E5515C-14

S E R V I C E N O T E

E5515C Wireless Communications Test Set (8960 Series)

2 Missing Washers on the DSP Fan Assembly Requires Replacement of the 5.8 DSP Board

Figure 1: Washer locations

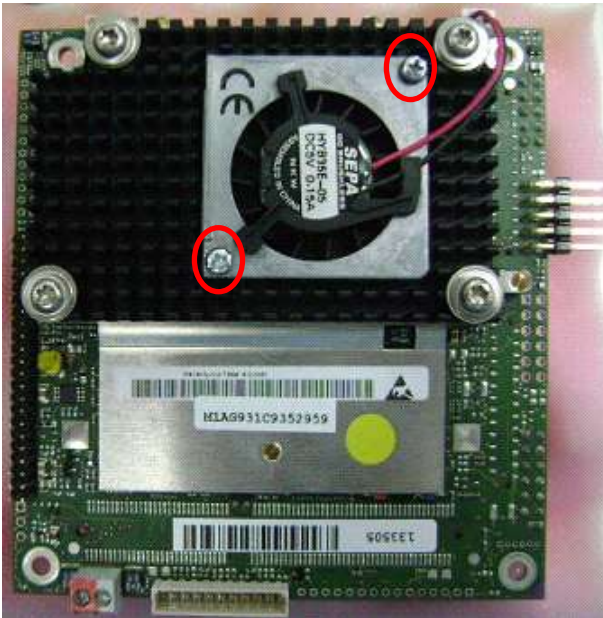
The two washers are located on the DSP fan assembly as shown in the picture below. The washer sits in between the screw head and fan assembly metal work.

If the 5.8 DSP fan does not have the washers, replace the DSP Assembly using the repair kit E5515-61845. Verify that the test set boots up and operates normally. Re-calibration is not required.

Figure 2: Washer is present

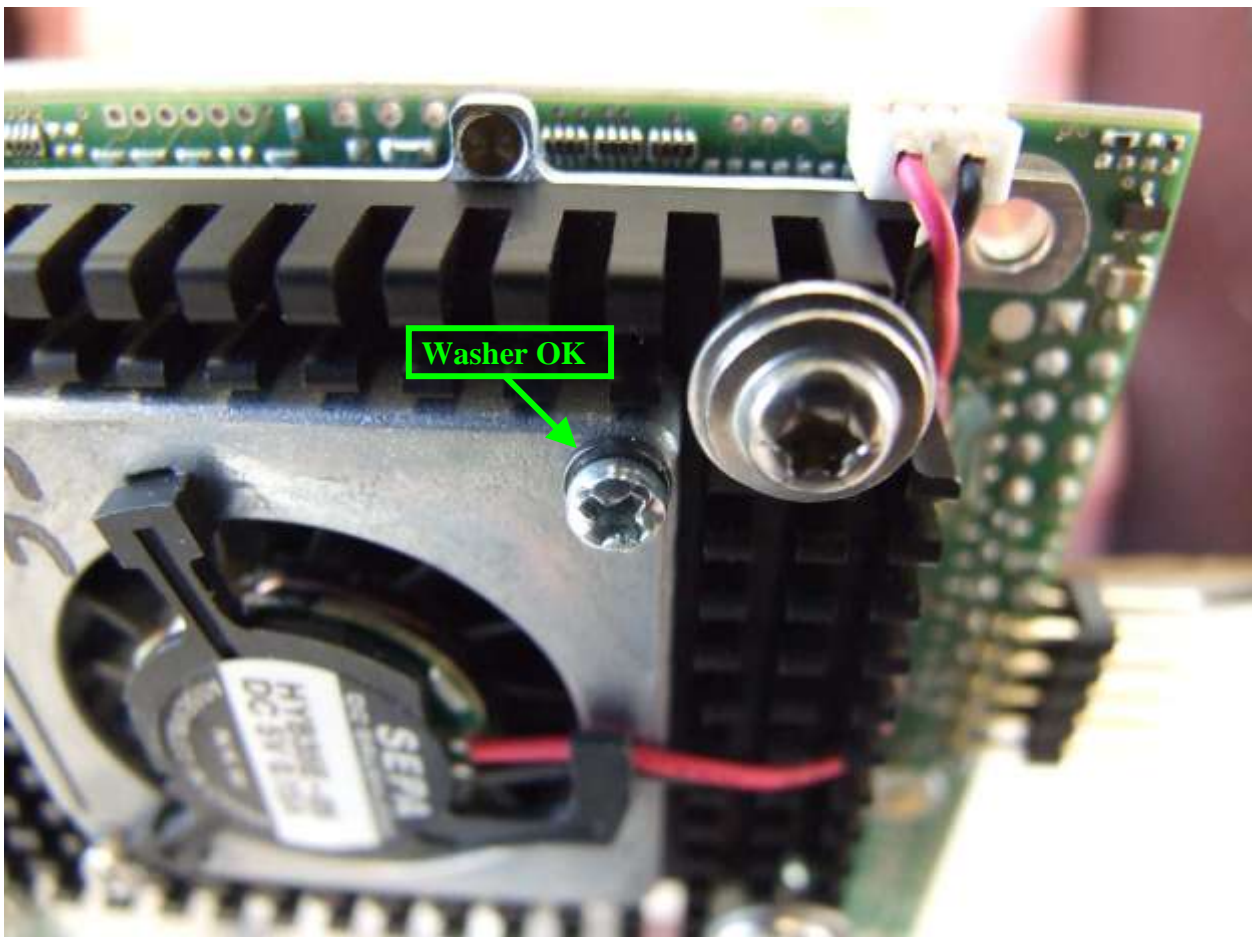
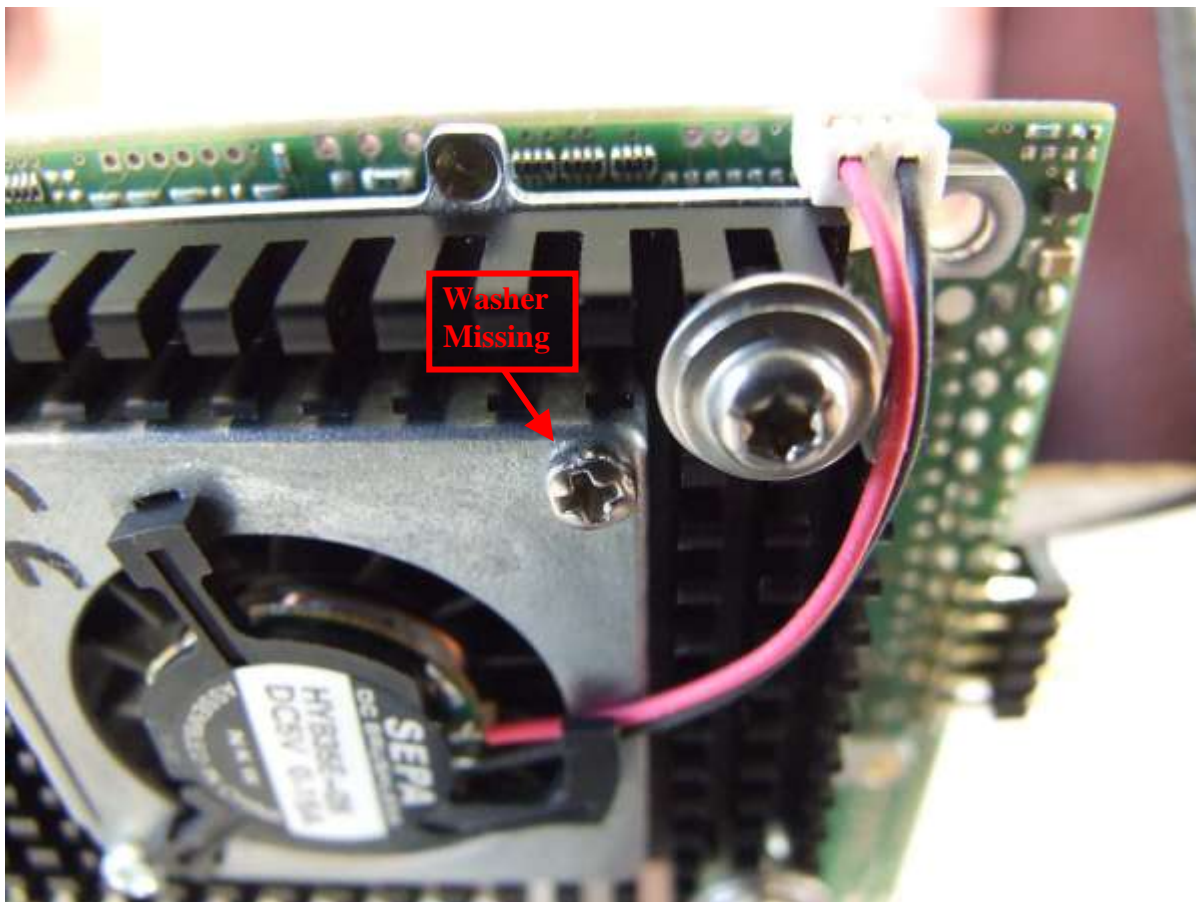
Without the washers, the screws bottom out and lift the heat sink from the sheet metal below, causing an air gap, less cooling effect and therefore a hotter running DSP which will eventually fail.
